Staff Report

Infill Housing Design Review Committee

File Number: 5-D-24-IH

Location: 3442 Gap Rd. **Parcel ID** 81 I S 02801
Zoning: RN-2 (Single-Family Residential Neighborhood)
District: Lonsdale Infill Housing Overlay District

SITE PLAN

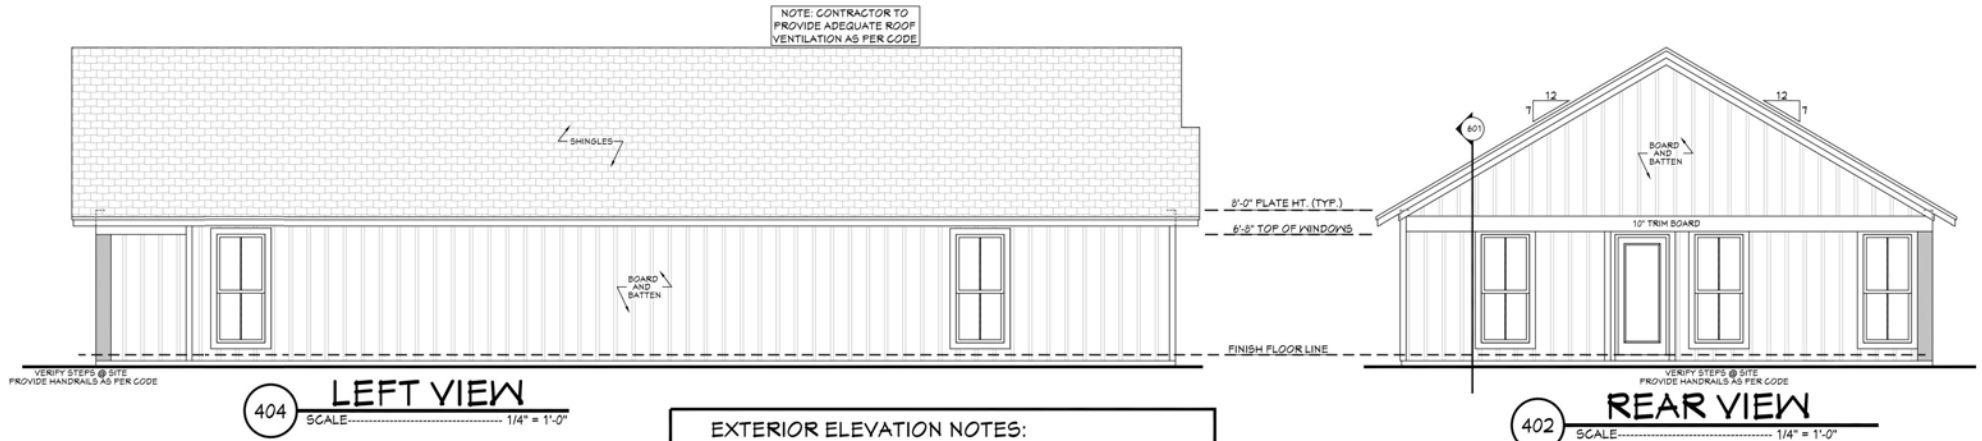
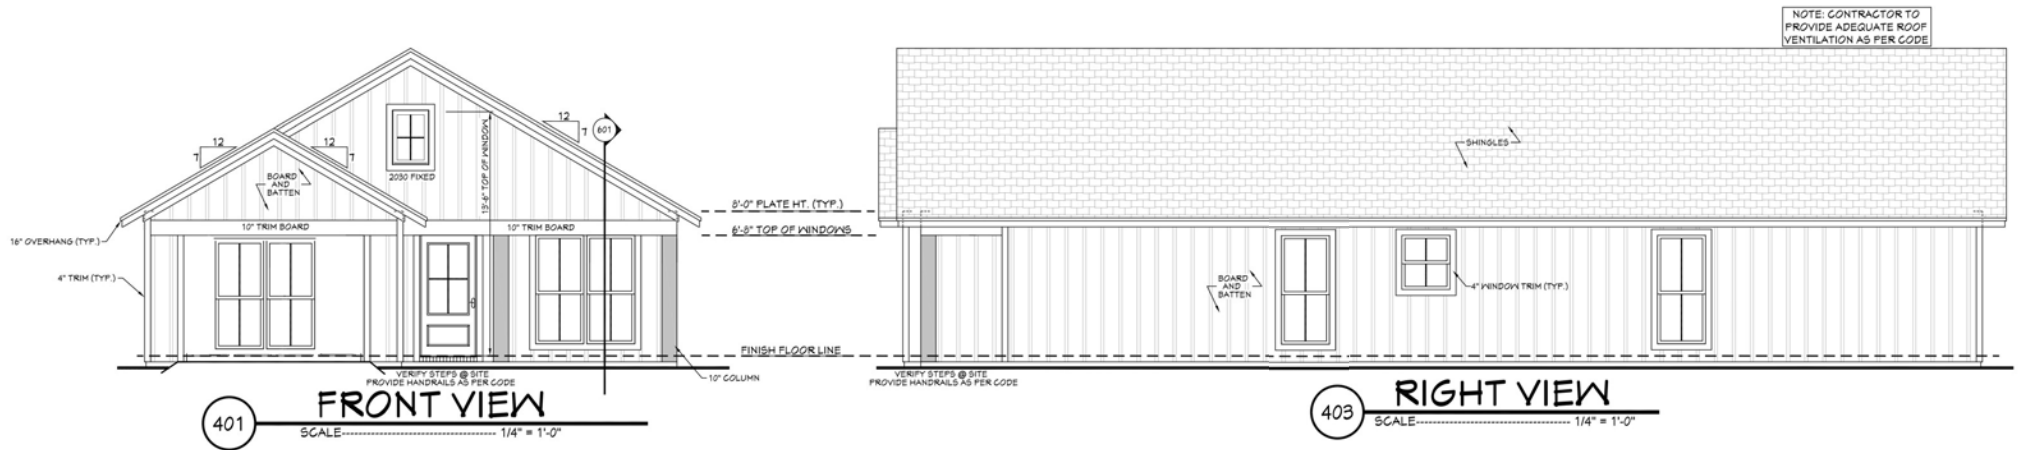
1. The house is proposed to be set 25' from the front property line. The block to receive new construction is relatively undeveloped; however, the existing houses on the block are set 15' and 18' from the front property line. The revised proposal has been aligned to align the four new houses on the block.

3. The application proposes a concrete driveway in the front of the house. Infill Housing guidelines recommend that on streets without alleys, parking areas should be at least 20' behind the front façade of the house with access limited to one lane between the street and the front façade. The turnaround may be required based on the site's topography and the conditions of Gap Road, but should be omitted if possible. Final site plans should meet City Engineering standards.

5. The revised application includes a 4'-5" deep entry stoop on the site plan and an 8' deep front porch on the floor plans. While an 8' deep porch meets the guidelines, the final site plan should include an accurate porch measurement.

9. Final site plans should include one native or naturalized shade tree in the front and rear yards. The lots currently feature a substantial amount of trees and other vegetation; existing trees should be retained if at all possible.

Front set back for each home will be normalized to create a consistent streetscape pattern.

Parking / driveway will be altered to meet guidelines

EXTERIOR ELEVATION NOTES:

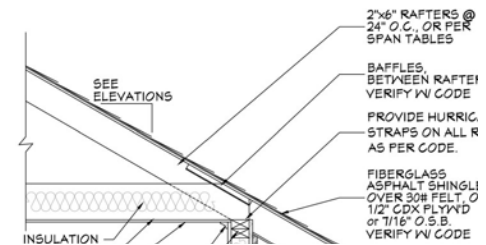
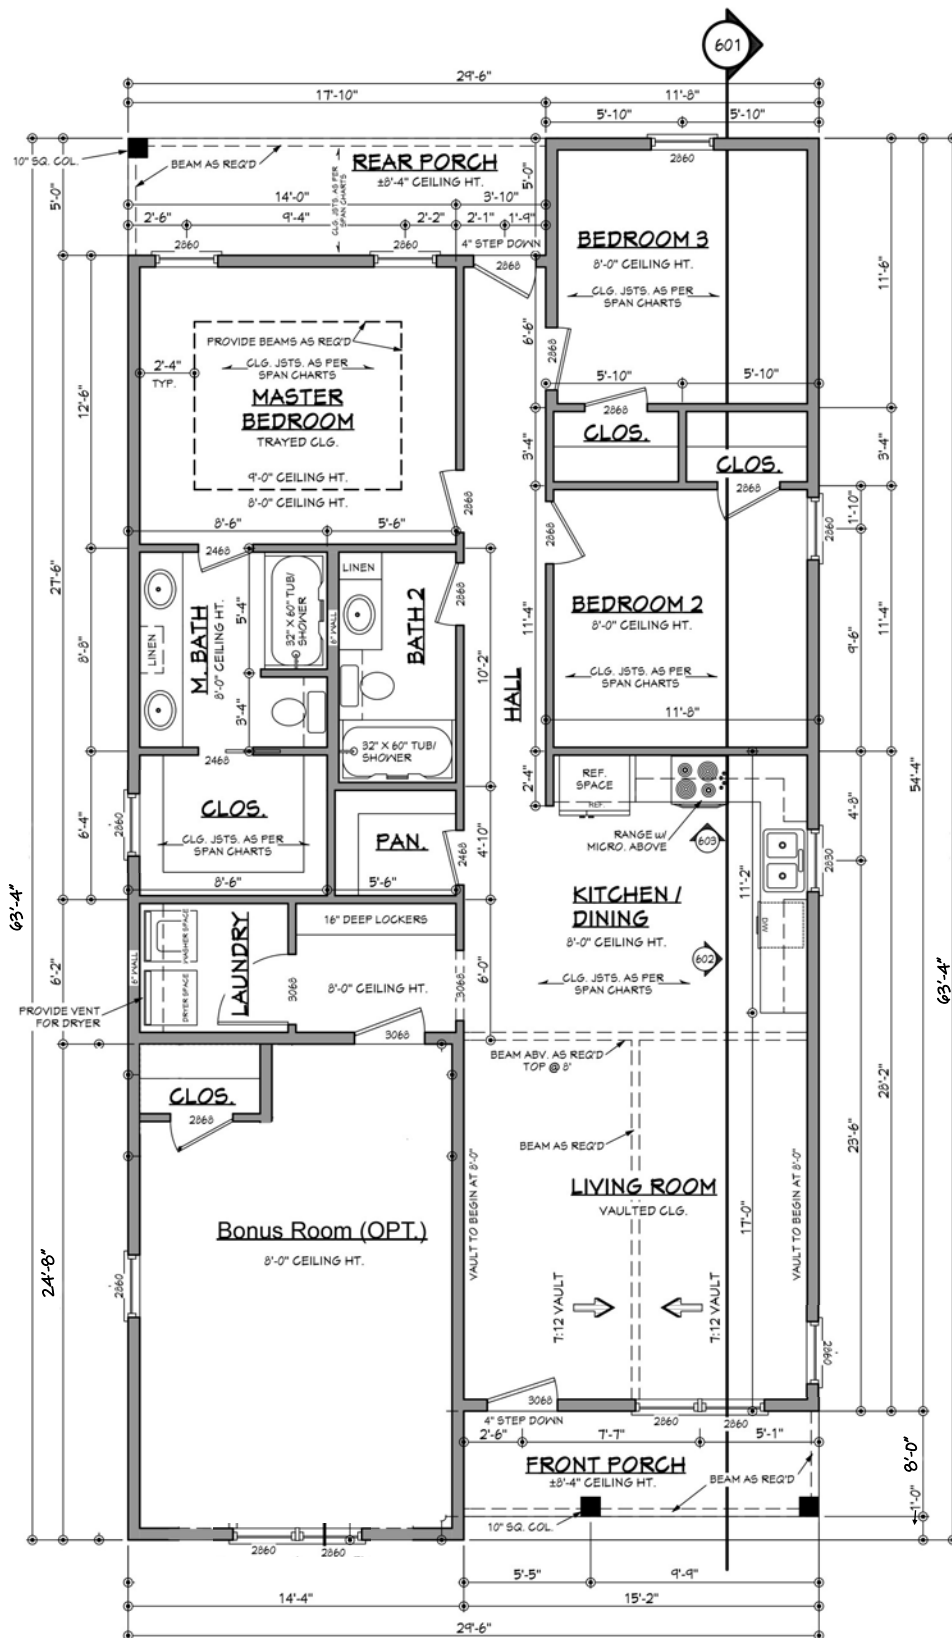
4. Overall, the one-story, three-bay façade is similar in scale and width to the context. The house is proposed for a concrete slab foundation; the foundation should be at least 12" tall to be compatible with the broader neighborhood. Topography of the site may also affect the house's foundation; the drawings depict a concrete slab.

6. Guidelines recommend window and door styles be similar, with similar proportions and ratio of solid to void, to historic houses on the block and in the neighborhood. The revised application includes two windows on the left elevation and three on the right elevation.

7. The proposed roof pitch (7/12) meets the design guidelines.
8. The application does not include information on siding materials. Guidelines recommend that clapboard-like materials be used in new houses and discourages vertical siding; the houses should feature horizontal lap siding instead of board-and-batten. Final drawings should accurately show the siding to be installed.

Siding will be horizontal lap siding

Exterior features will differ in siding color & porch railing and post types from adjacent homes

201 FOUNDATION PLAN
SCALE: 1/4" = 1'-0"

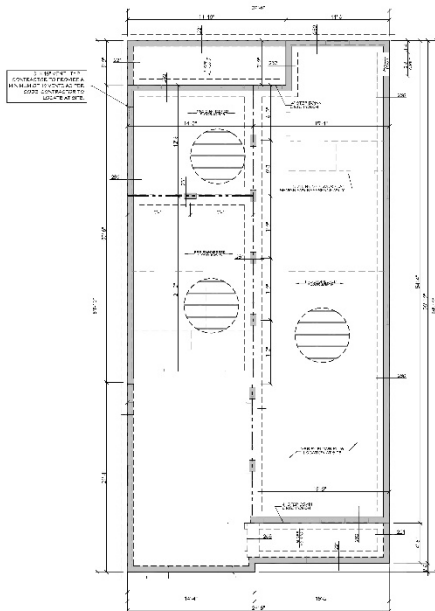
3) foundation to be elevated at least 12 inches to reflect historic houses in the neighborhood, with a revised foundation profile submitted to staff;

Foundation plan (below) does not specify a total height. Crawl space will exceed the 12 inch requirement
